**Village of Holmen
Planning Commission Minutes
January 31, 2023**

**Possible Recommendation and Action on Site Plan & Architectural Review (SPAR)
Petition from owner Matthew Harper, of Ragz Shop, LLC, for a new 5-unit commercial business condo with residence at 1749 Cole Court**

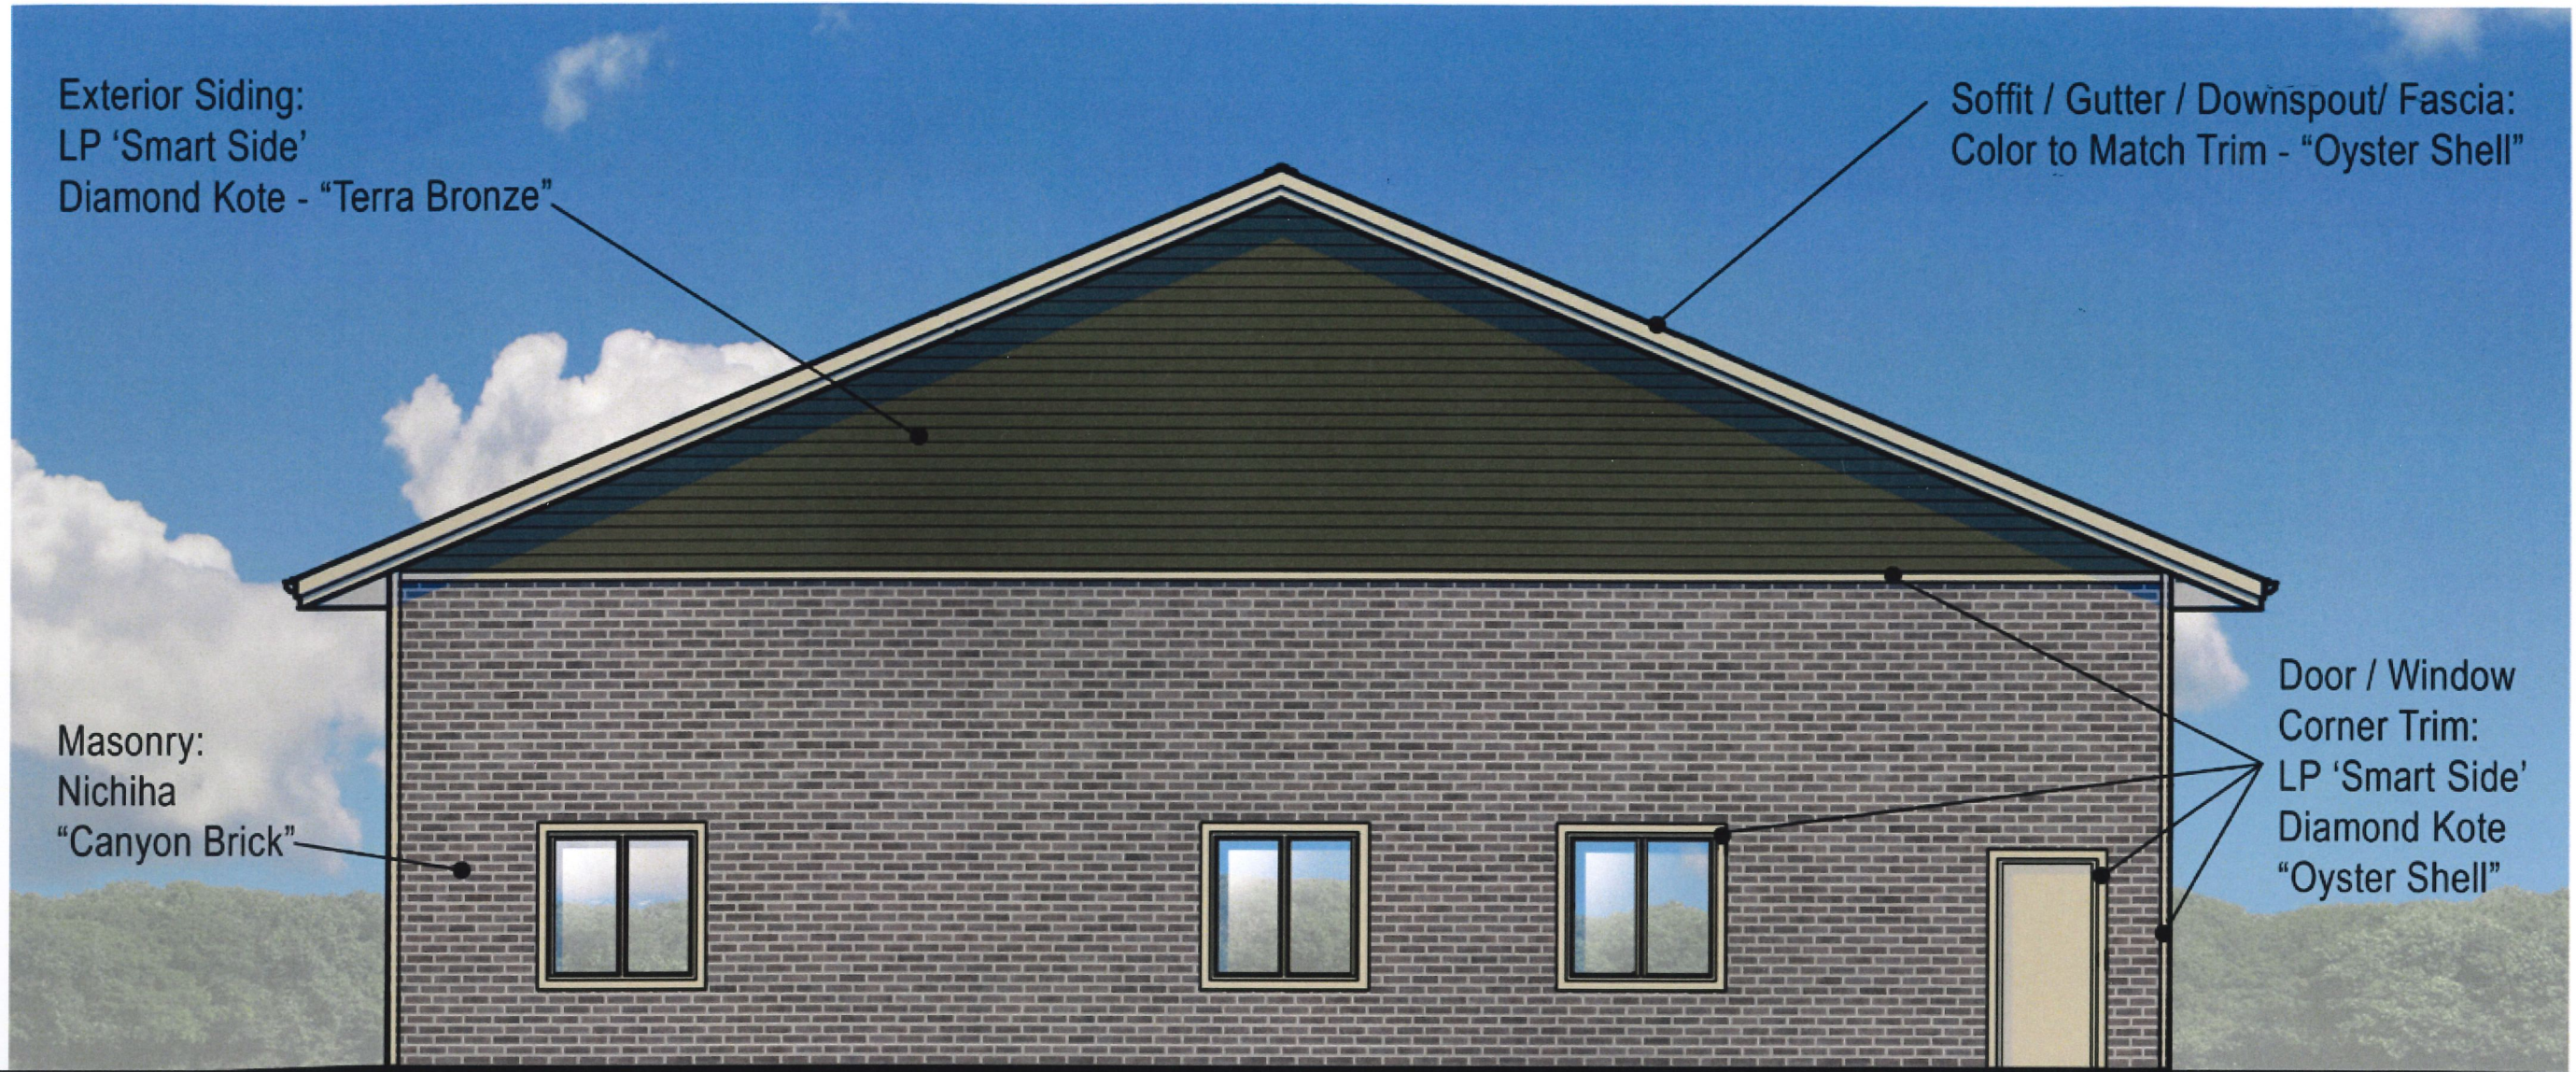
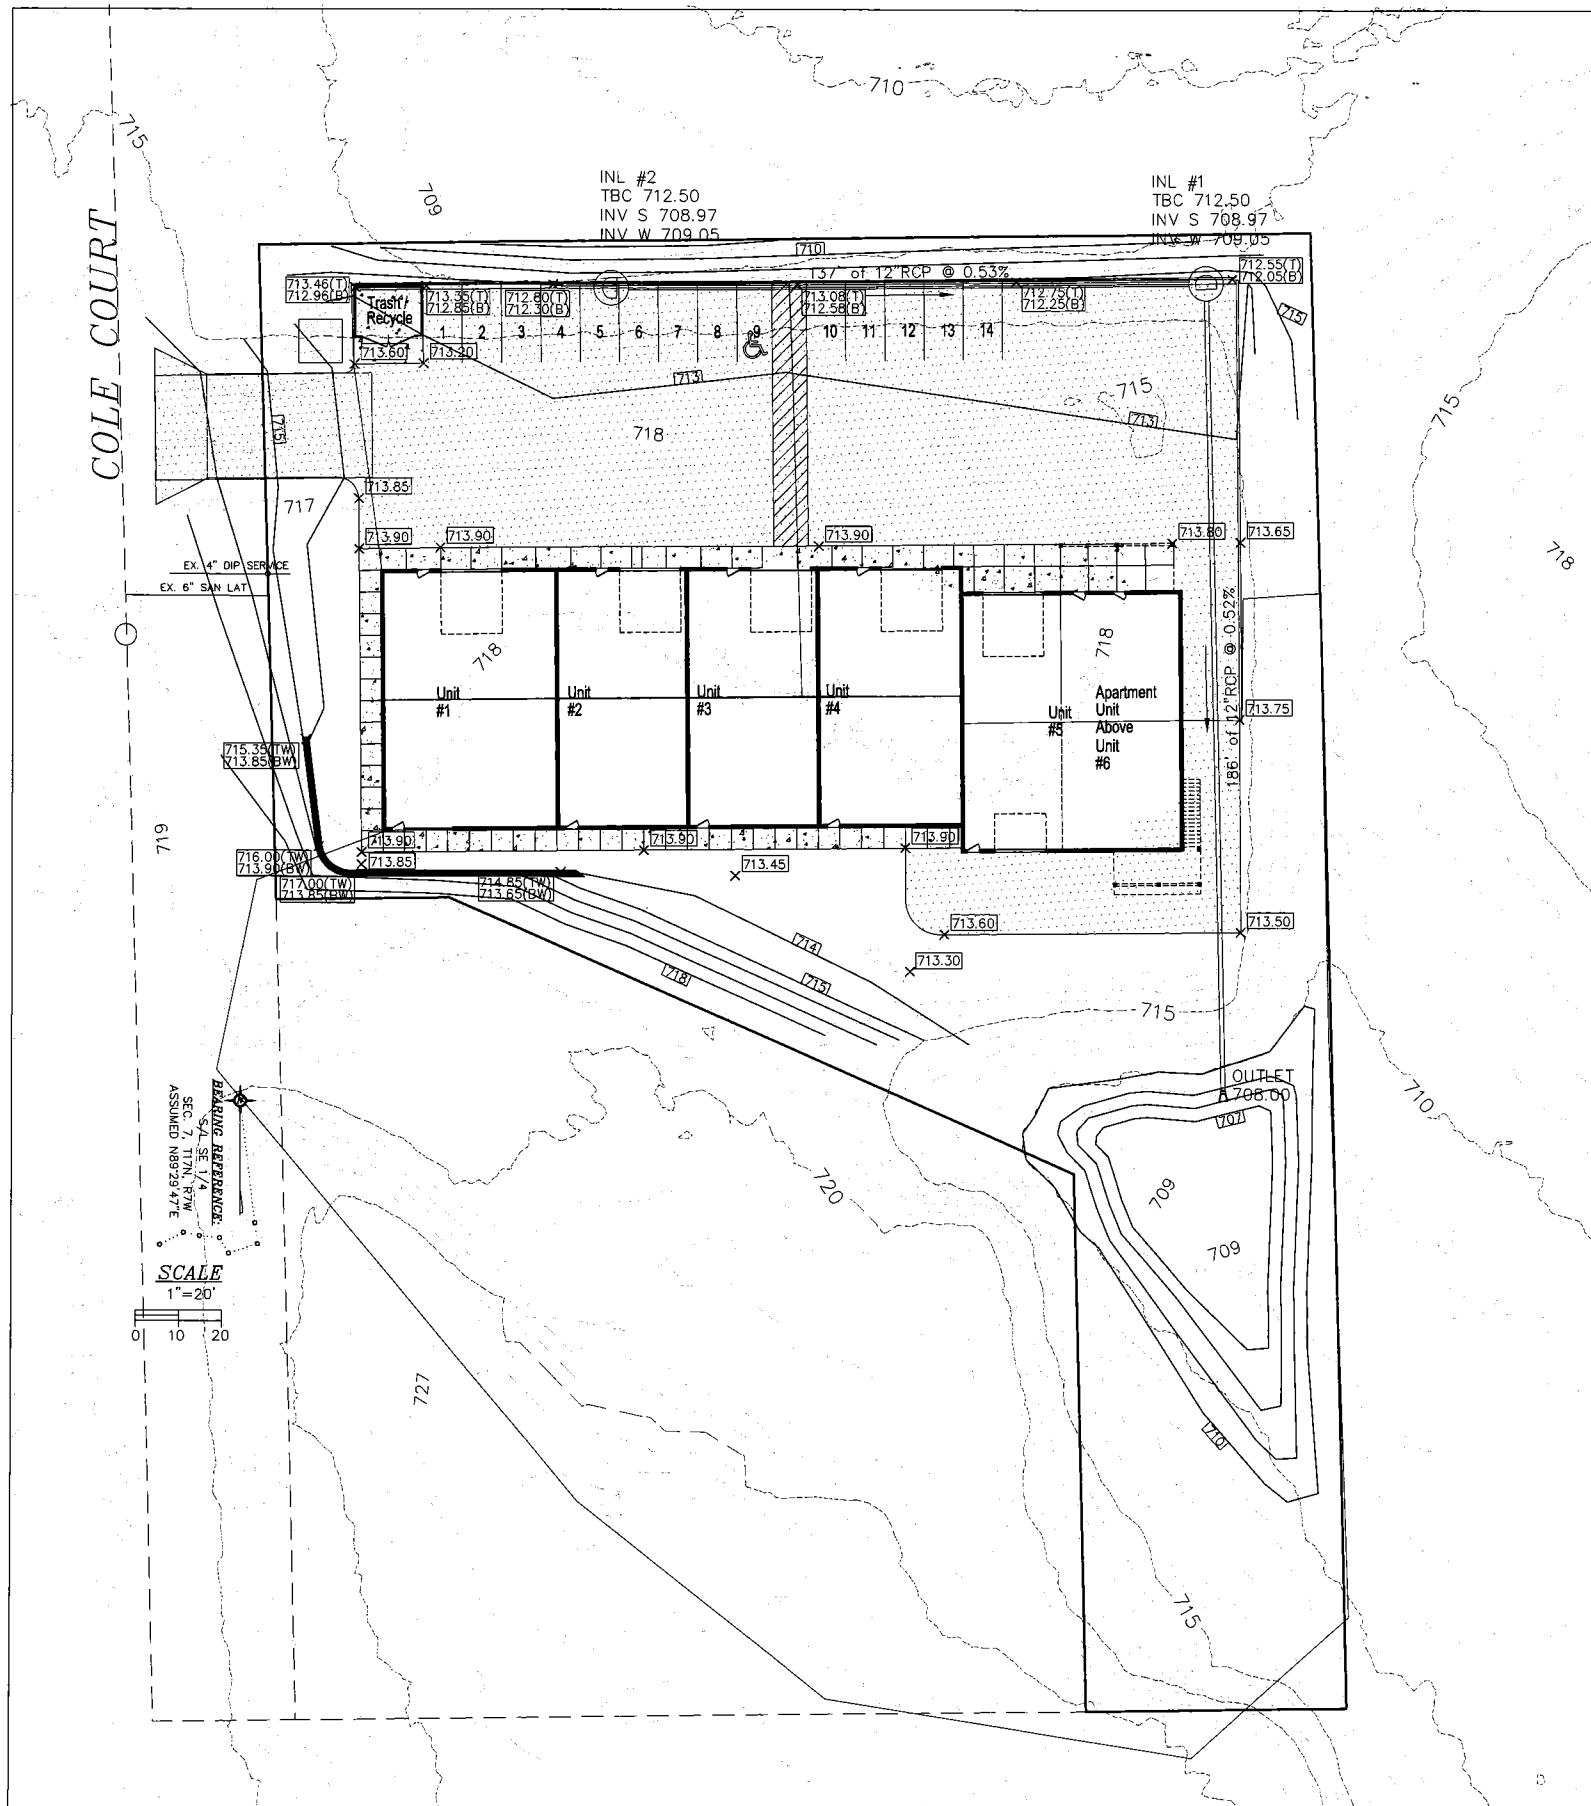
Member Stanek noted the discrepancy between sheets C-1 and A-2; with A-2 not showing the offset between the 4th and 5th units. He asked if the brick material would be required on both wall faces of the corner. Administrator Heinig stated the offset is planned and that the masonry material would be required on both wall faces.
